**STAFF REPORT**  
**COMMUNITY DEVELOPMENT DEPARTMENT**

HEARING DATE: 8/16/2022  
TO: Mayor & City Council  
FROM: Alan Tiefenbach, Associate Planner  
208-489-0573  
SUBJECT: FP-2022-0022  
Skybreak No. 2  
LOCATION: 7020 S. Eagle Rd., in the SE ¼ of the  
NW ¼ of Section 4, T.2N., R.1E.  
(Parcel # S1404233660)

Final plat consisting of 62 lots and 12 common lots on 11.12 acres of land in the R-8 zoning district.

B. Final Plat (date: 6/02/2022)

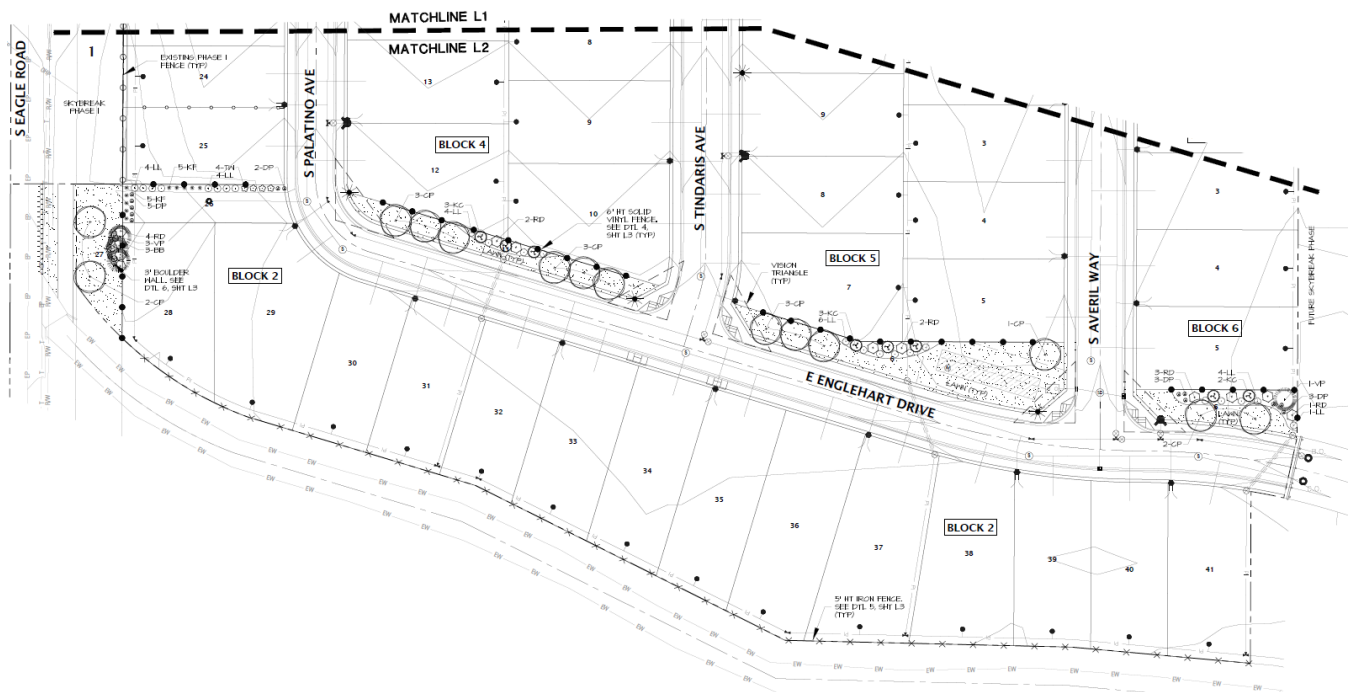
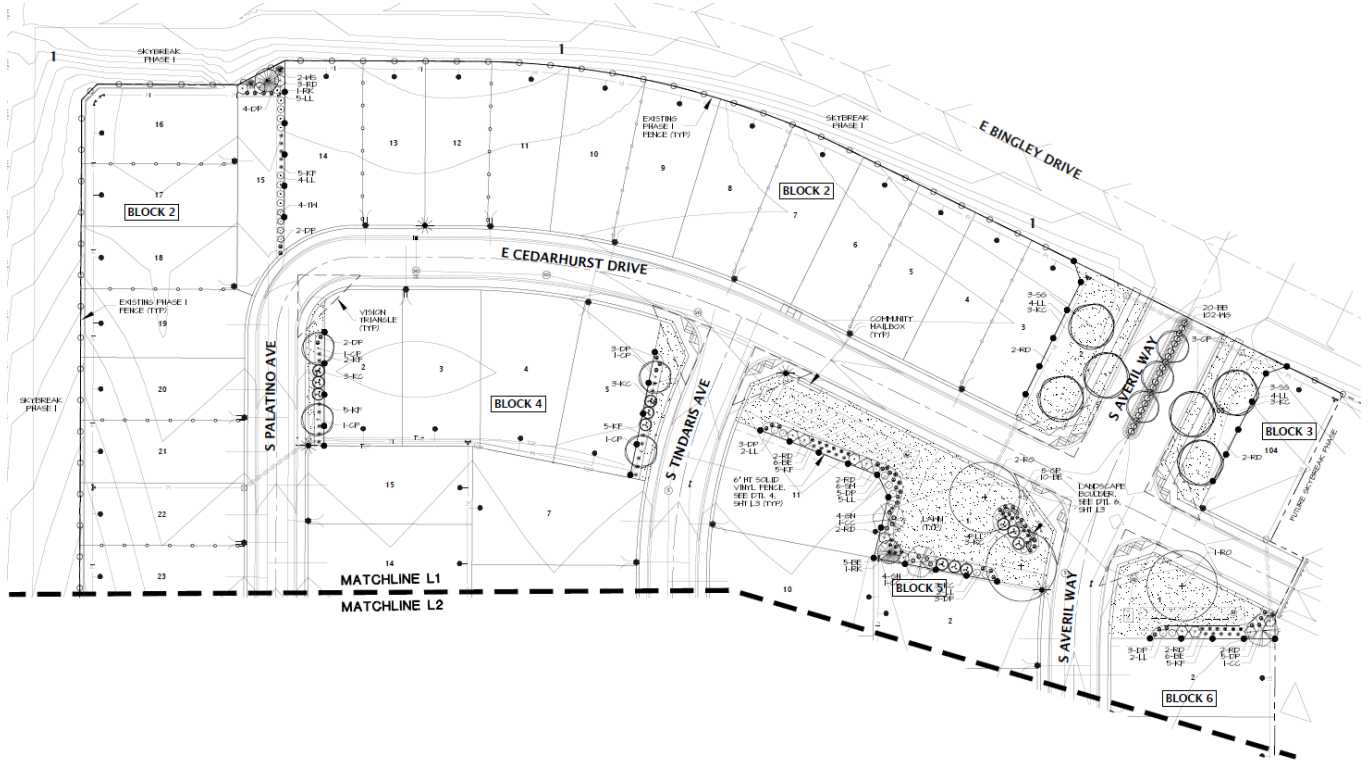
Staff has reviewed the proposed final plat for substantial compliance with the approved preliminary plat in accord with the requirements listed in UDC 11-6B-3C.2. It appears Lot 7, Block 2 does not meet the minimum 40 ft. frontage required in the R-8 zoning district. Otherwise, because the final plat does not increase the number of building lots and/or decrease the amount of qualified open space as shown on the approved preliminary plat, with the exceptions listed above, all lots within the development comply with the dimensional standards listed in UDC Table 11-2A-6 for the R-8 zoning district. Staff finds the proposed final plat is in substantial compliance with the approved preliminary plat as required.

2. Prior to City Engineer signature on the final plat, the final plat prepared by Sawtooth Land Surveying LLC stamped by Jeff Beagley, dated: 4/2022, included in Section V.B shall be revised as follows:

- a. Lot 7, Block 2 shall be revised to meet the minimum lot frontage requirements (40 feet) for the R-8 zoning district per UDC Table 11-2A-6.
  - b. Plat Note No 6 – add instrument number.

- c. Plat Note No. 14 – add instrument number.
  - d. Plat Note No. 15 – add instrument number.
  - e. Plat Note No. 16 – add instrument number
3. Pathways and adjoining fencings and landscaping shall be constructed consistent with the standards as set forth in UDC 11-3A-7A7, 11-3A-8 and 11-3B-12C.
